Tom Cat Designs LLC Protective Hull Modeling & Simulation Results For Iteration 1

24- October- 2011

Underbody kit is bolted through frame on both sides (8) bolts

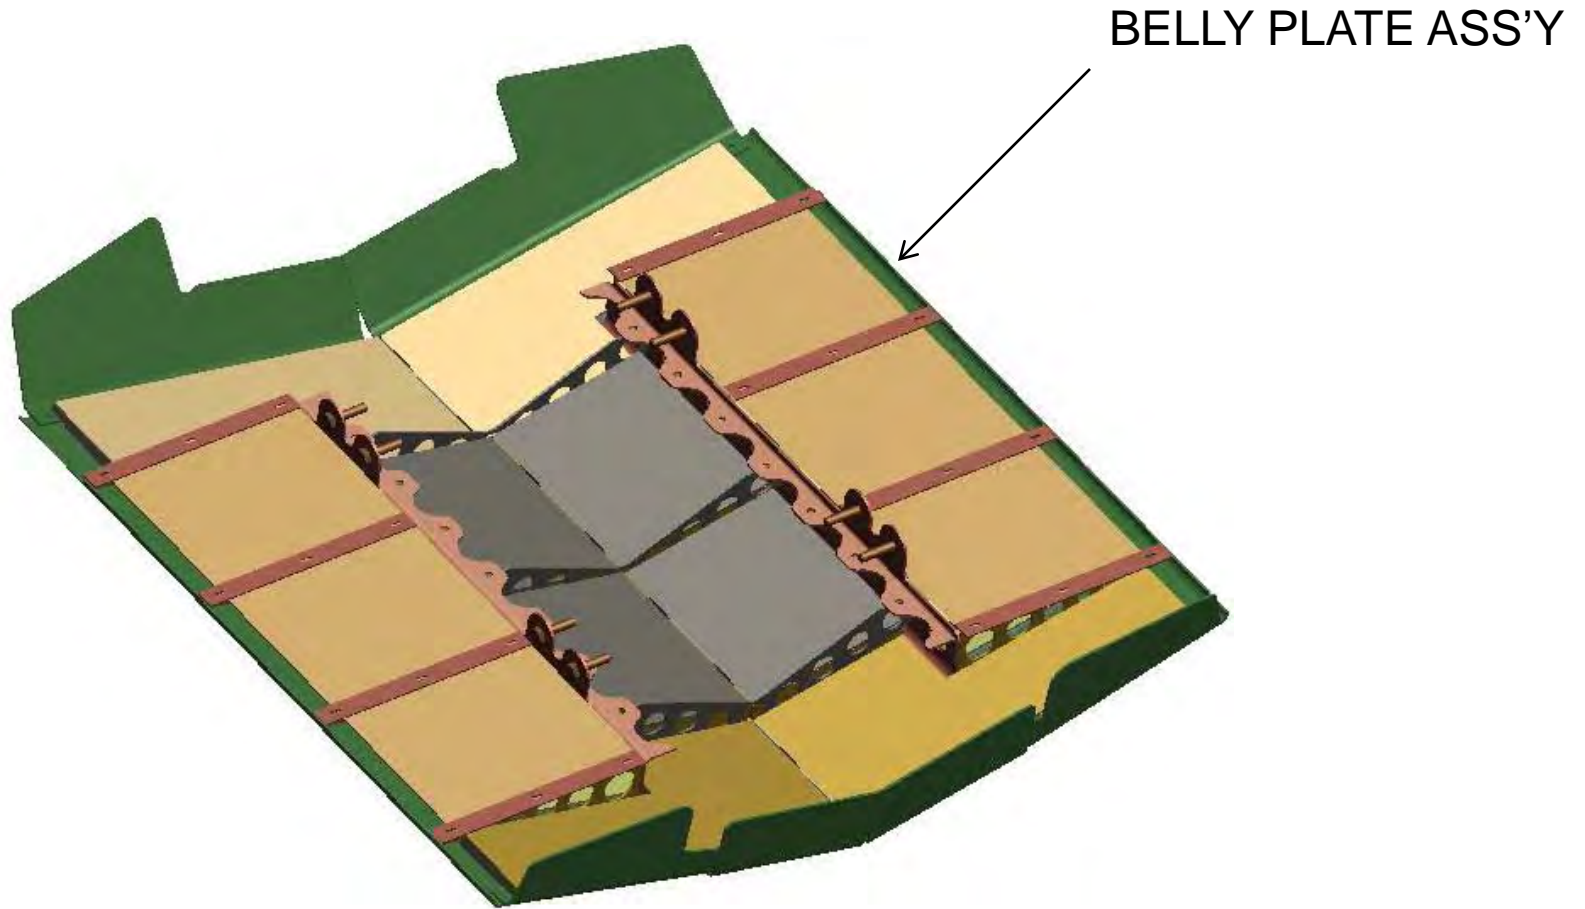
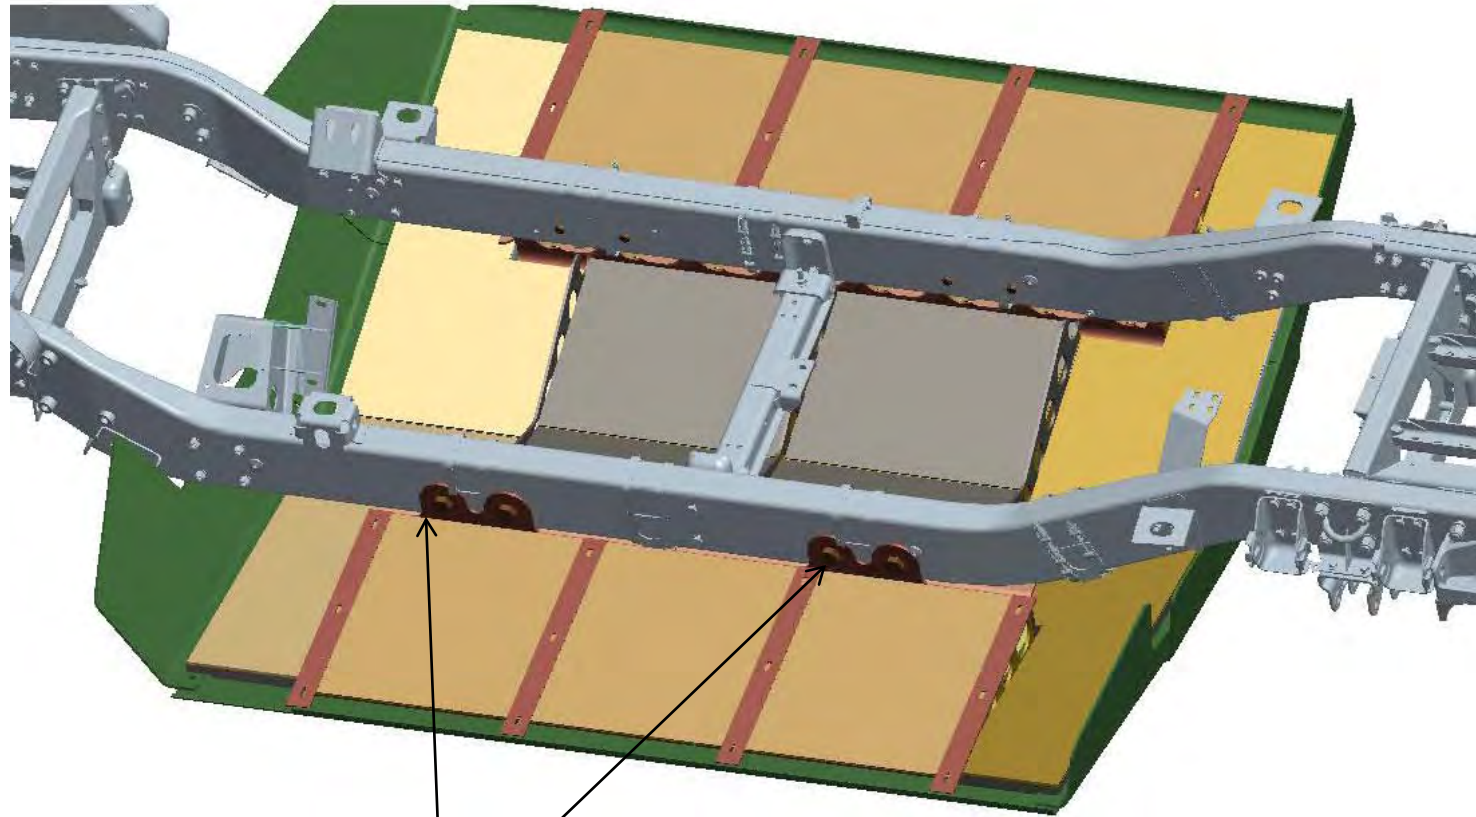
- During installation/removal of the underbody kit, the attachment locations are potentially difficult to reach.
- All 8 bolts are blind operation.

BELLY PLATE IS BOLTED TO VEHICLE FRAME

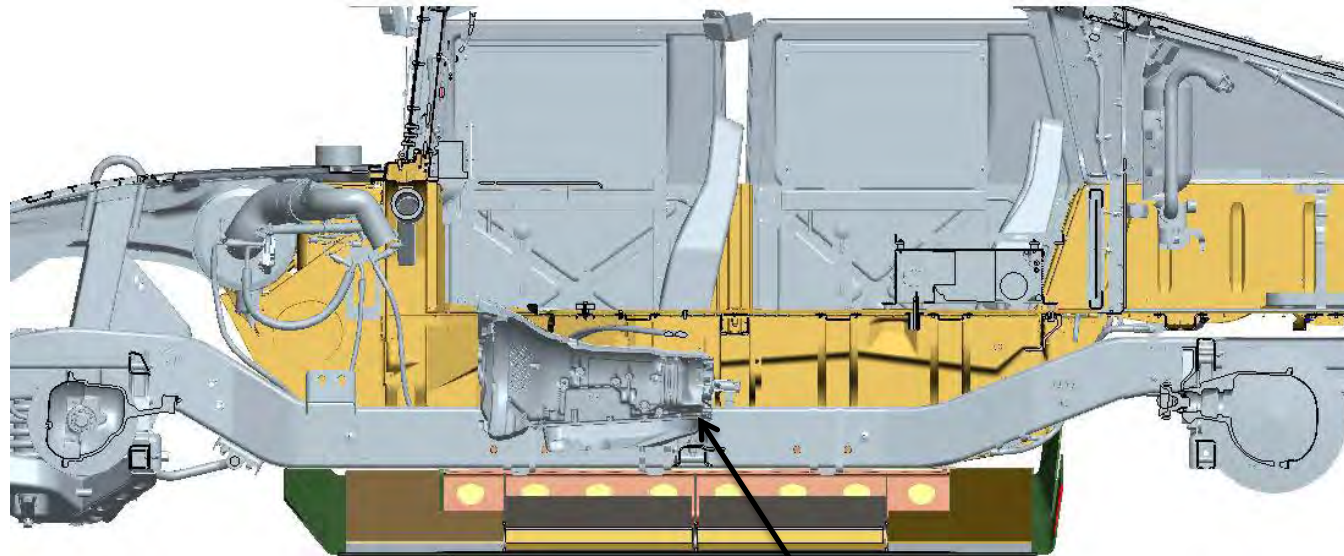
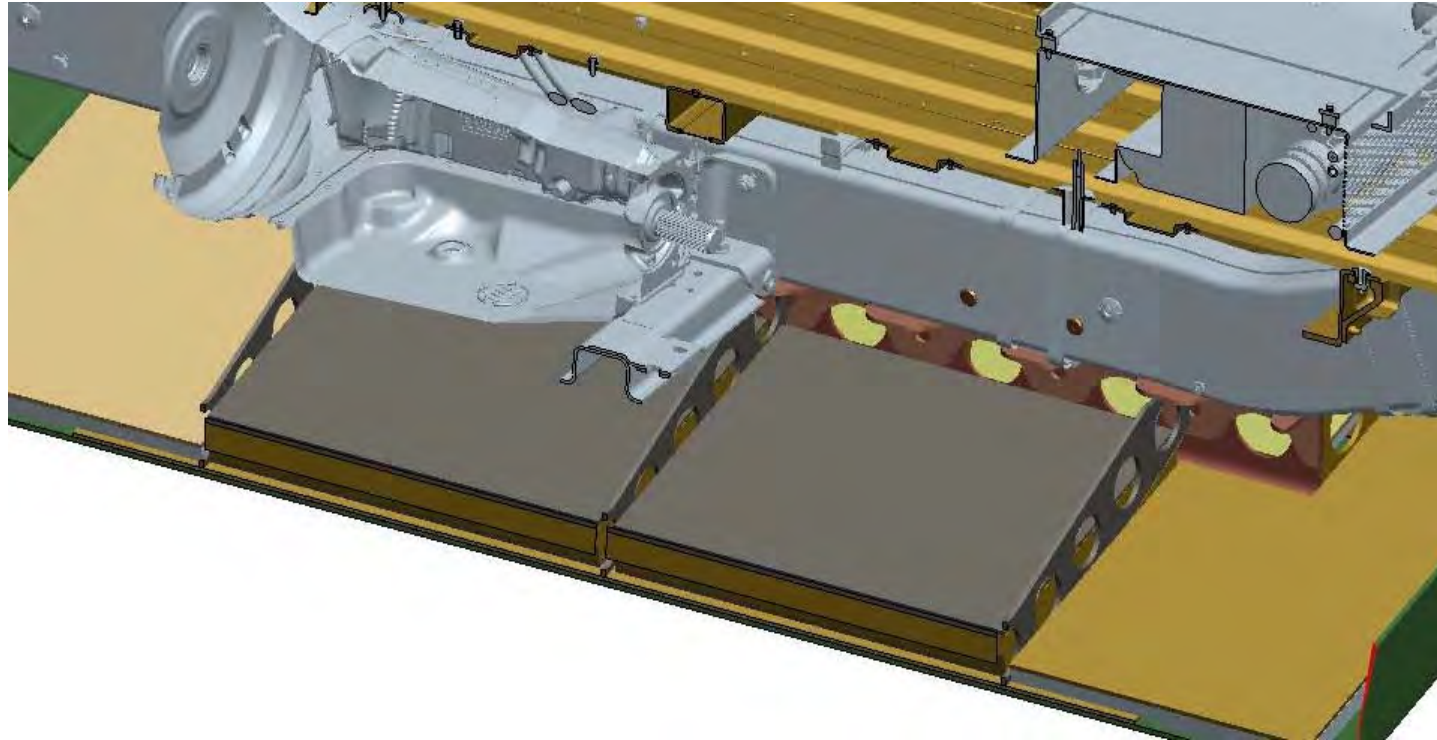
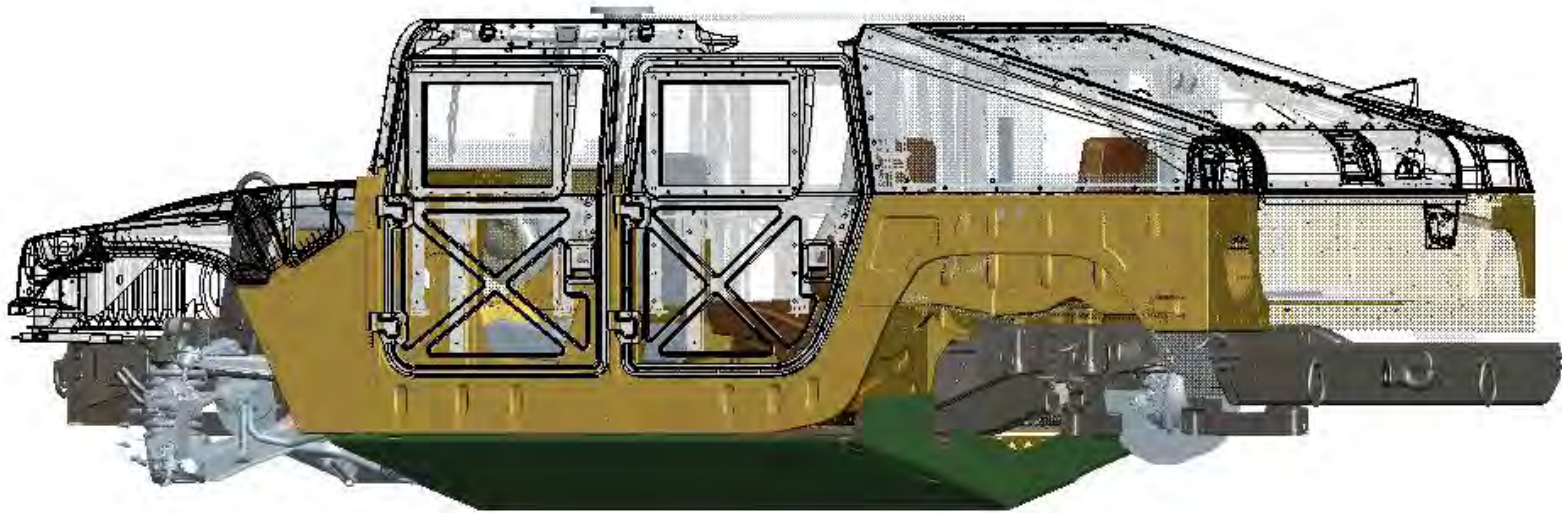
- During installation/removal of the underbody kit, the attachment locations are potentially difficult to reach.
- All 8 installation bolts are blind operation.

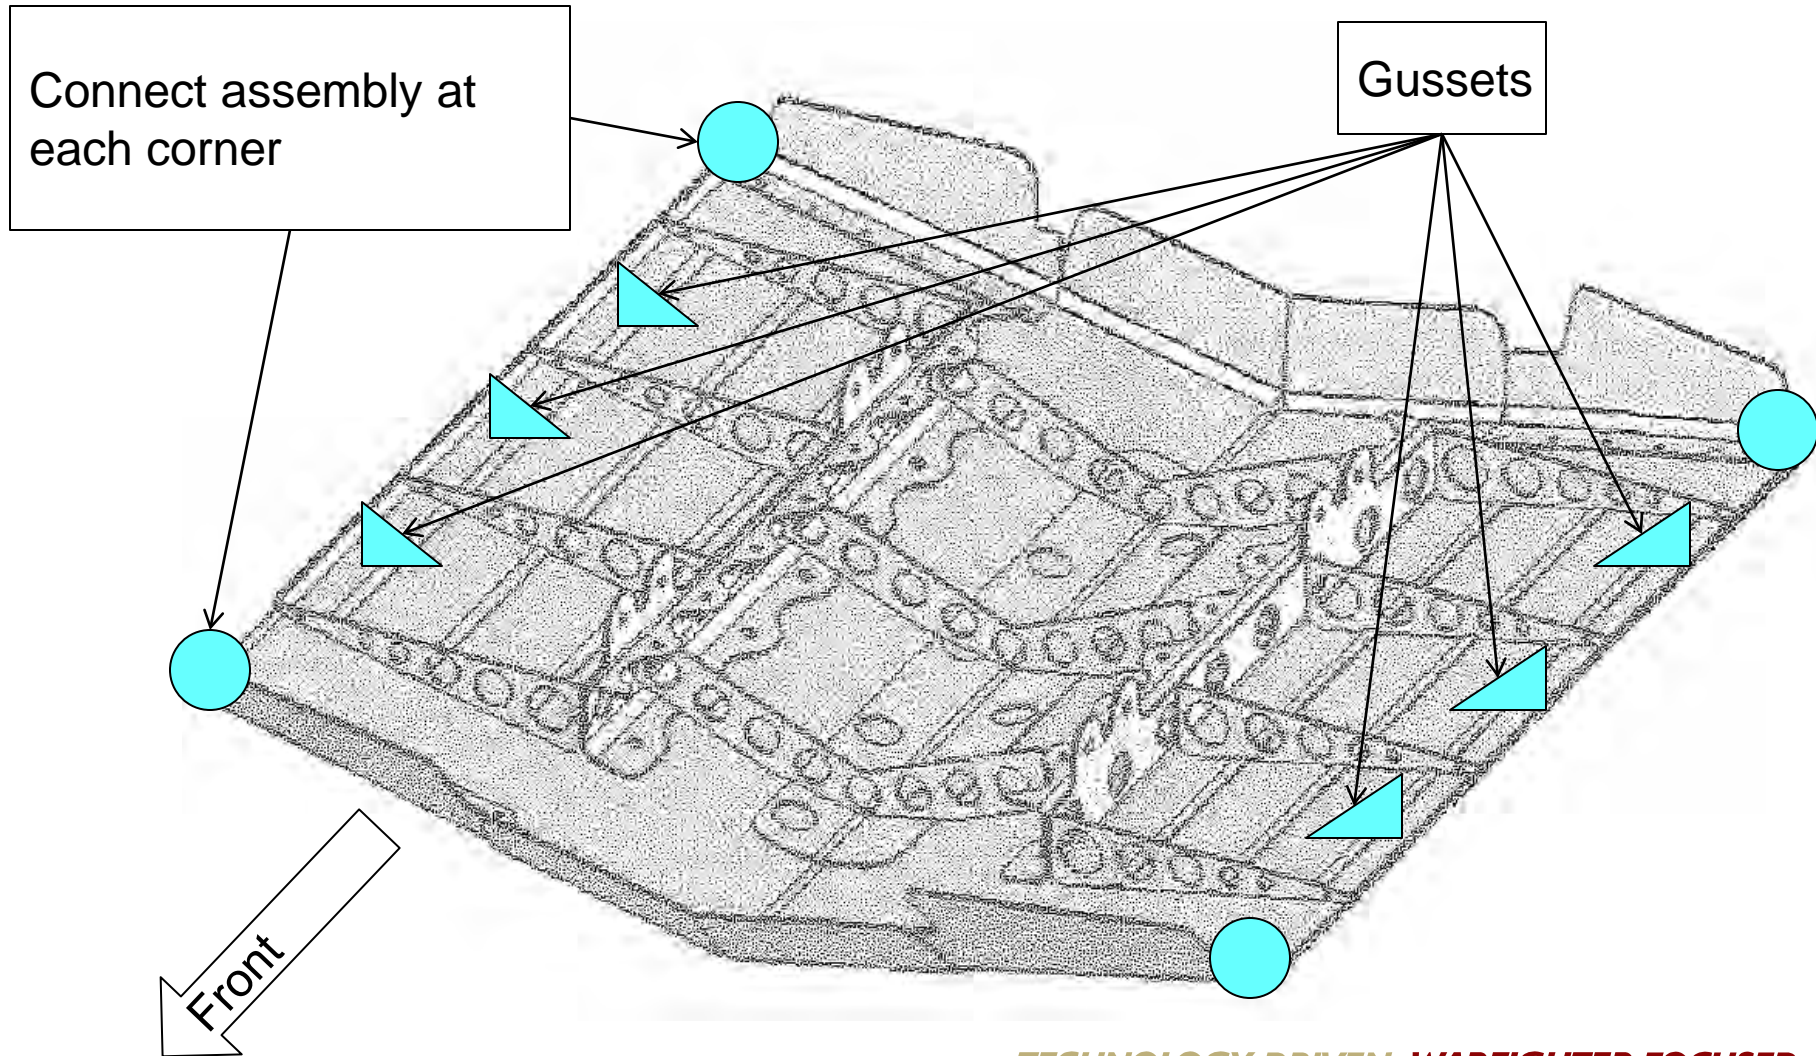
- **Performance of the 9° and 22° V-Hulls Produced:**
 - High accelerative loads
 - Unfavorable displacement

Extend Length and
Connect Assembly To
Side Sills

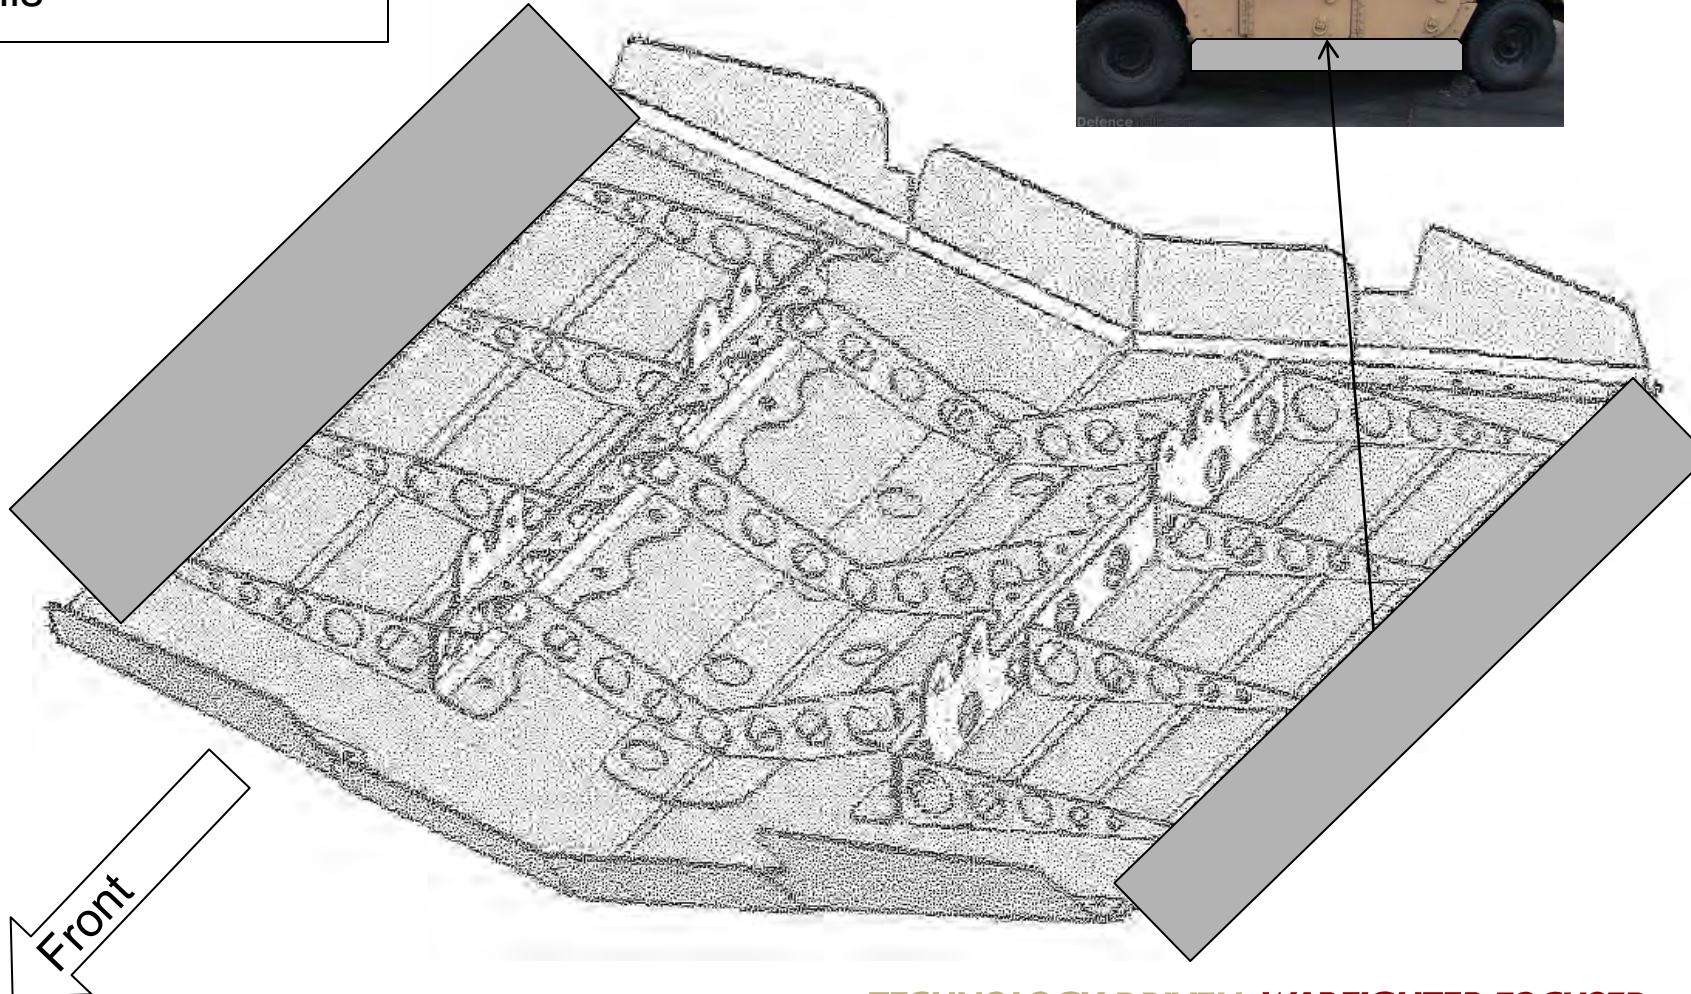
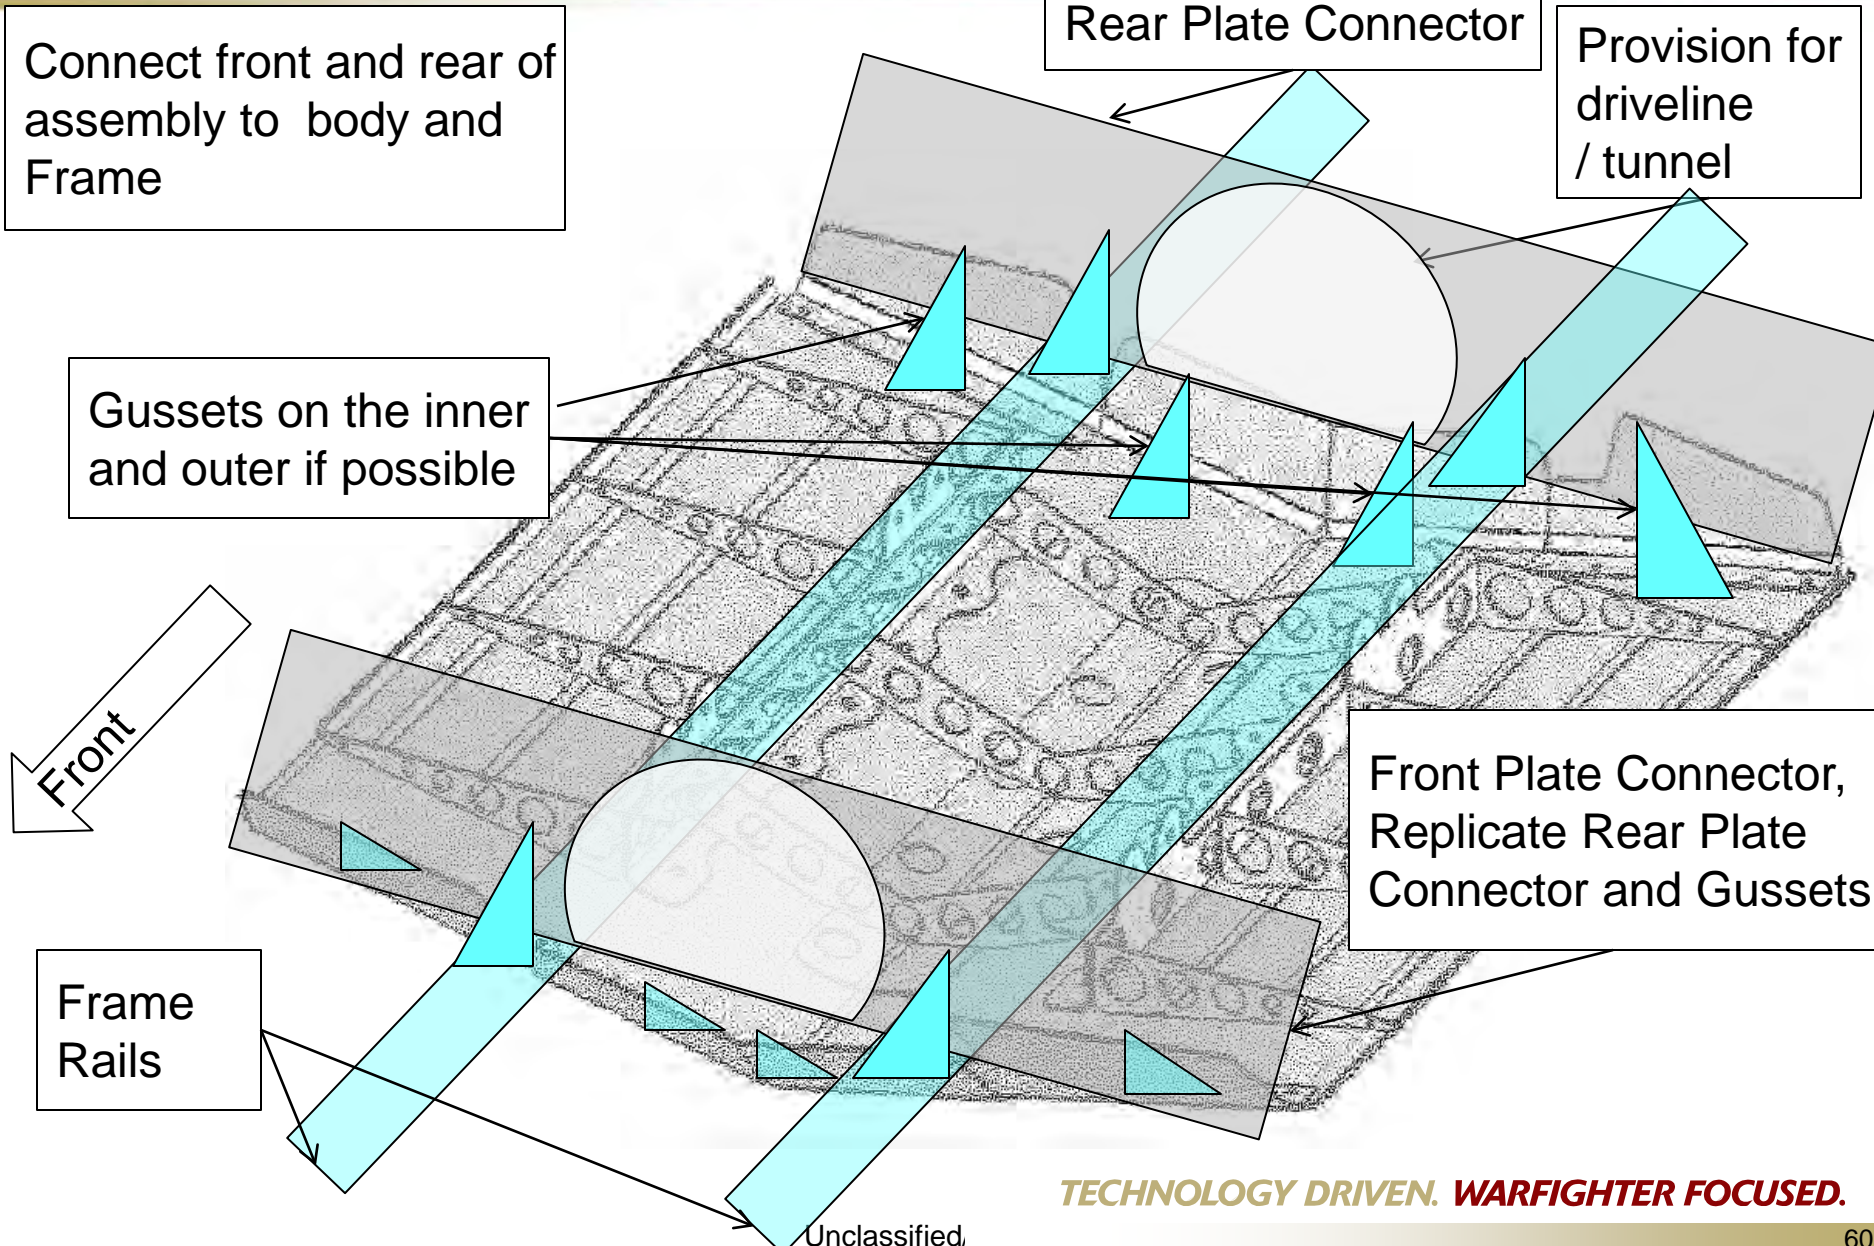
- The system in its current configuration provides assembly issues due to the accessibility of the mounting holes
- Underbody produces an unfavorable drop in mobility
- Deformation to the underbody is not favorable and does not provide adequate protection from an underbody blast perspective
- To produce favorable results for Fit and Finish, Mobility and Blast it is strongly recommended that a complete redesign by the Contractor be considered
- The current design is not feasible for Fit and Finish, Mobility or Blast

Increase overall
Thickness to 2"
